Chip Errata for the MPC8260 PowerQUICC II Family

This document describes all known silicon errata for the MPC8260 PowerQUICC II family of integrated communications processors. See [Table 2](#) for a list of devices.

Figure 1. Transmit Timing for Cell-Level Handshake

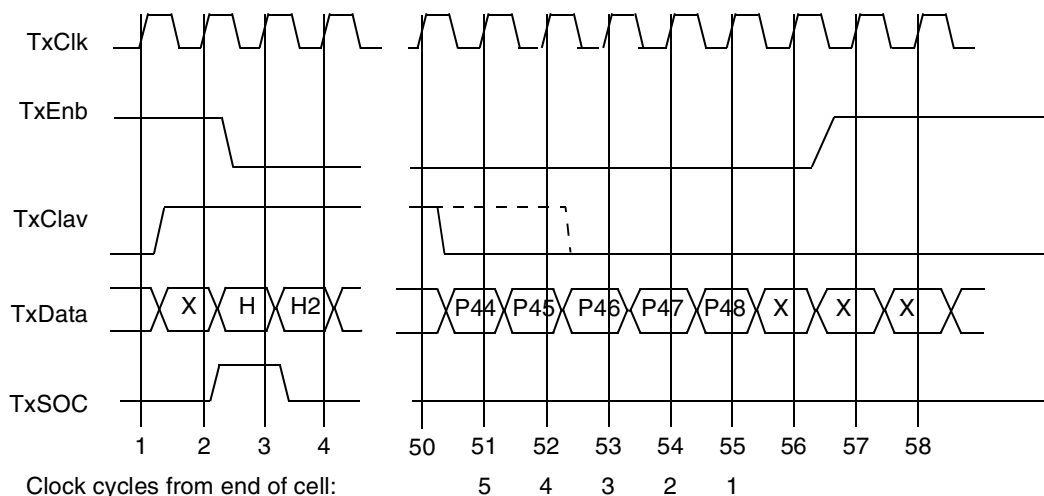
- Master should not poll RxClav or pause cell transfer at 4 cycles before the end of cell transfer. Master should poll 2 cycles before the end of the current cell or later. This can be achieved by introducing a cell-to-cell polling (and transfer) delay, which is equal or larger than one cell transfer time. If this can be achieved, the impact on performance is minimal.
- Configuring ATM only on FCC1 and setting FPSMR[TPRI] ensures highest priority to FCC1 Rx. In addition, for CPM utilization lower than 80% (as reported by the CPM performance tool based on UTOPIA maximal bus rate) the CPM performance is enough to guarantee that the RxFIFO does not fill up.

- Multi-PHY with single Clav polling—Master should ensure that the address corresponding to an MPC826xA slave is not placed on the address bus before 5 cycles before the end of a cell transfer to that slave.
